UNSW Biological Sciences Project Stage 2

Volume 12: Building Code Report

Design Development Report
BS2-LT161026

RE: BUILDING CODE OF AUSTRALIA ASSESSMENT
BIOLOGICAL SCIENCES PROJECT, BUILDING D26 STAGE 2 SSD APPLICATION (7865)

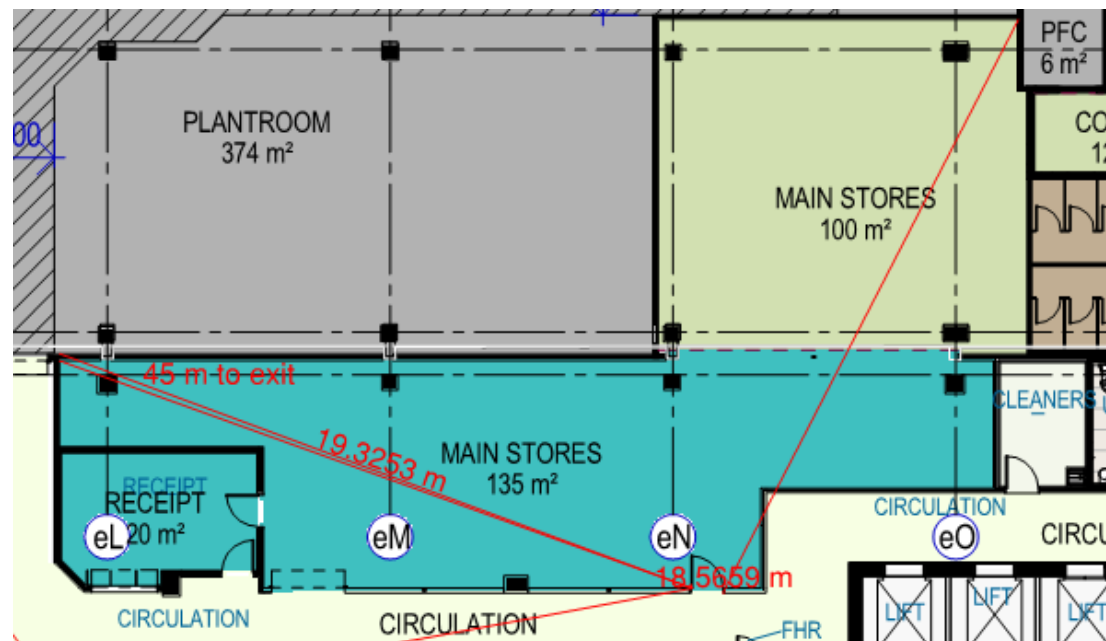
- 5.1 The fire engineer is to review the existing FER for the Wallace Wurth building to ensure that proposed works do not adversely affect the existing FER.
- 5.2 Note that egress from the Wallace Wurth East wing L7 plant room appears to rely on egress to D26 roof top (refer to point 8.4 of Wallace Wurth FER) from which there is access to the existing D26 east fire stair. Such egress is to be maintained and identified on the plans.
- 5.3 The following areas are more than 20 m to a point of choice and **performance justification** is required:

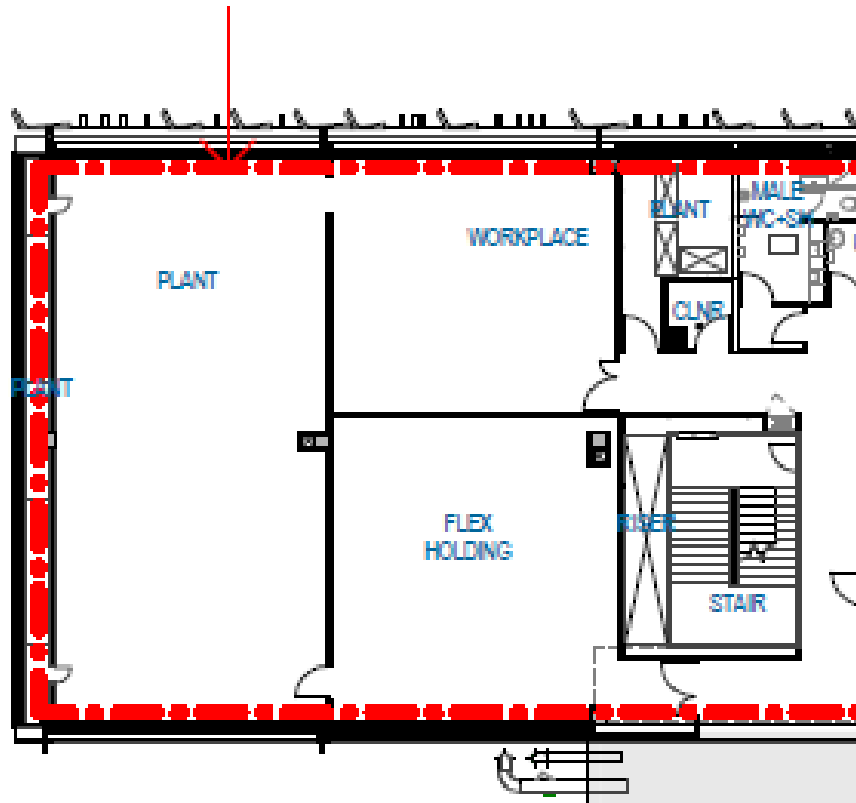
- (a) LGF main stores – 19.3 m (more than 20 m if racking provided)

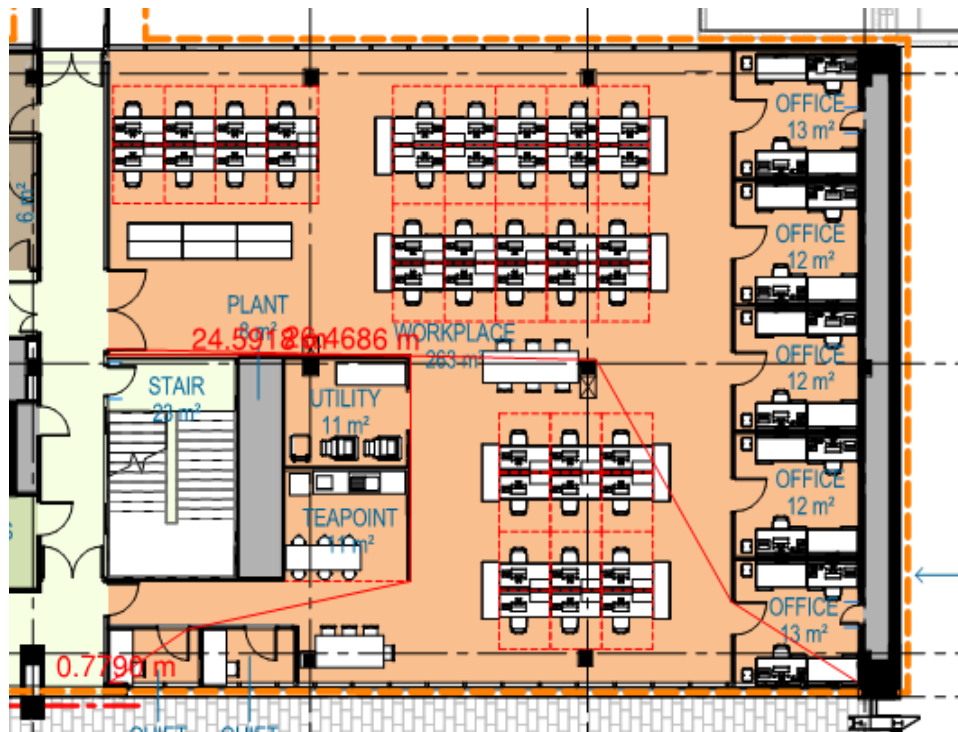
(b) Level 6 west plant room - 27 m.

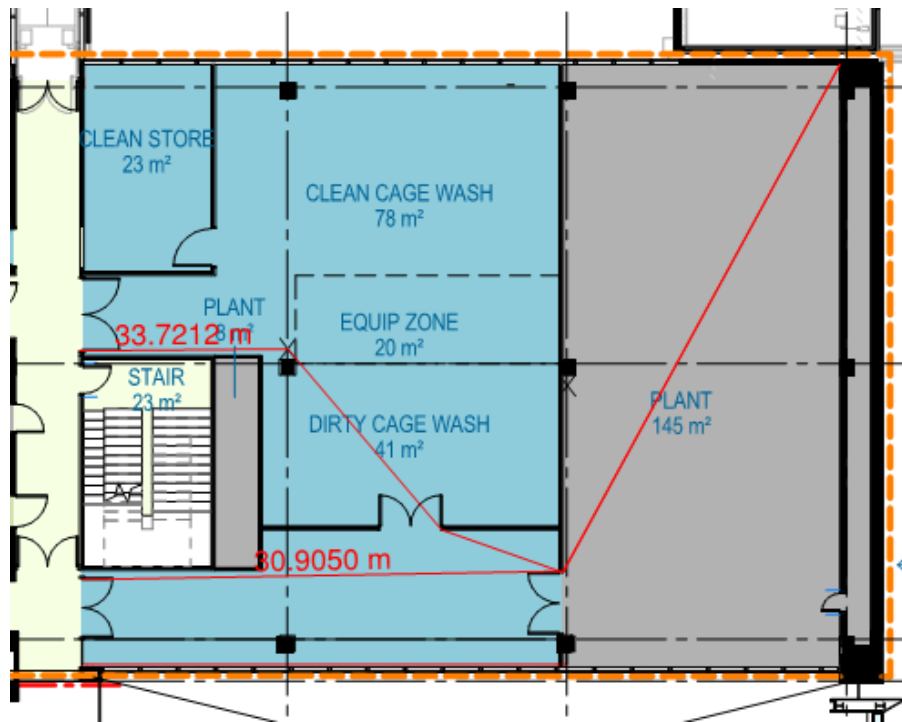
(c) Level 2, 3, 4, & 5 east and west workplace – 26.7 m

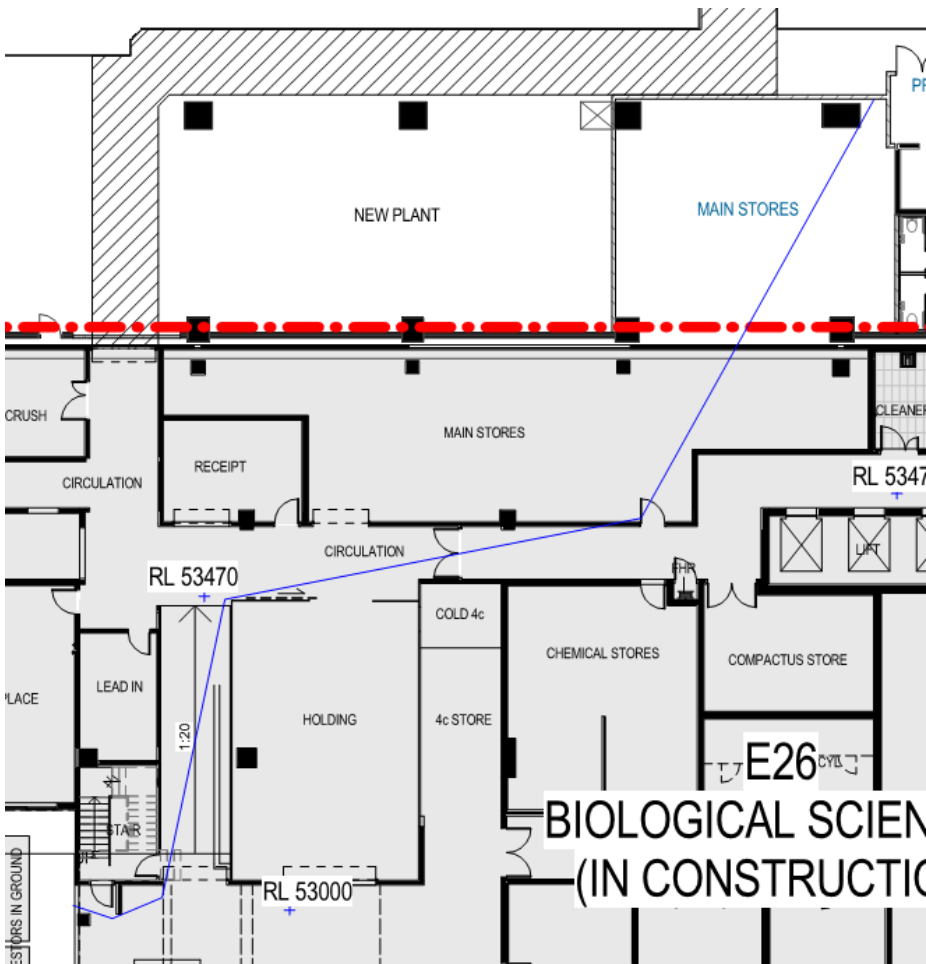
(d) Level 6 east plant – 33.7 m open floor plan and if not traveling through atrium.

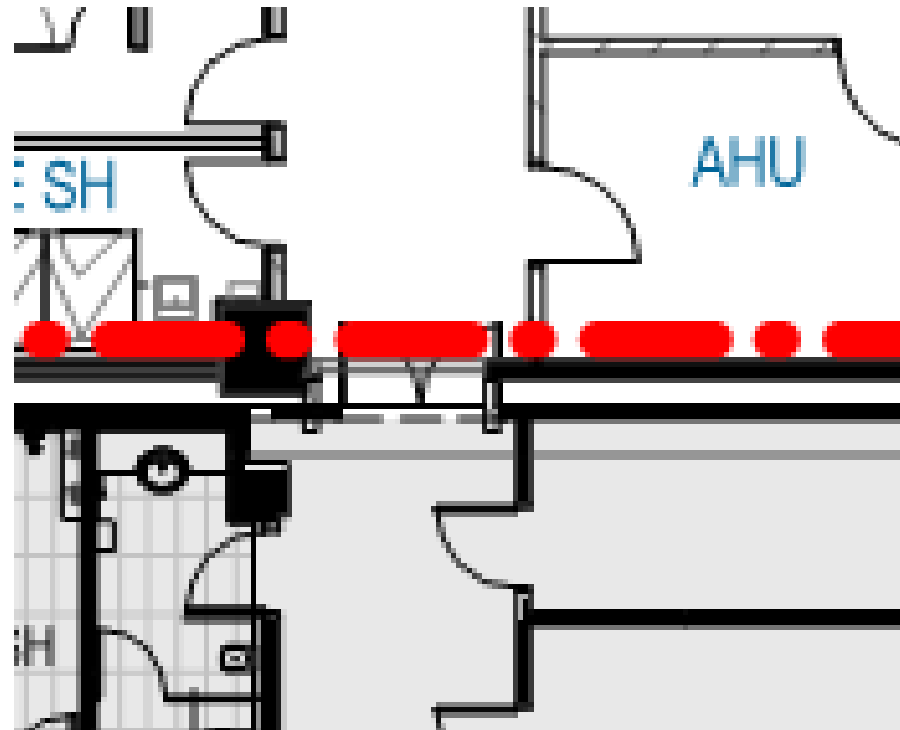
5.5 The **fire engineer** is to advise if any of the alternative solutions in the existing Building E26 Sciences Building FER that are impacted by the connection to Building D26.

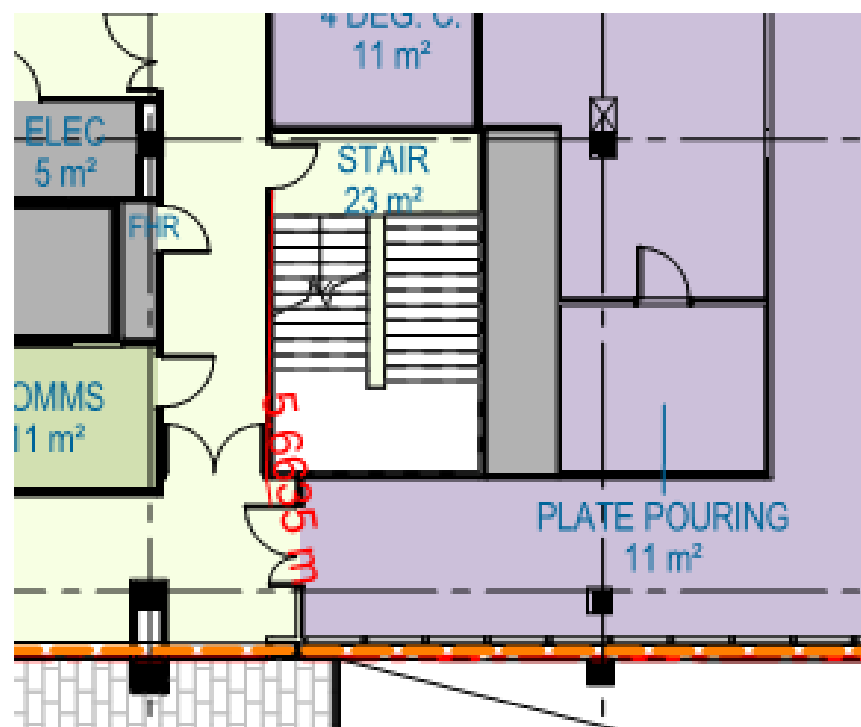
5.6 The LGF door between Building D26 and E26 at eastern end has been assessed as a horizontal exit from the D26 side. The double door is to be redesigned to swing into Building E26.

5.7 The following exits are more than 60 m apart and performance justification required:

(a) LGF D26 west stair to east horizontal exit – 71 m.

(b) L1, 2, 3, 4, 5 & 6 west exit to east exit – 61.5 m.
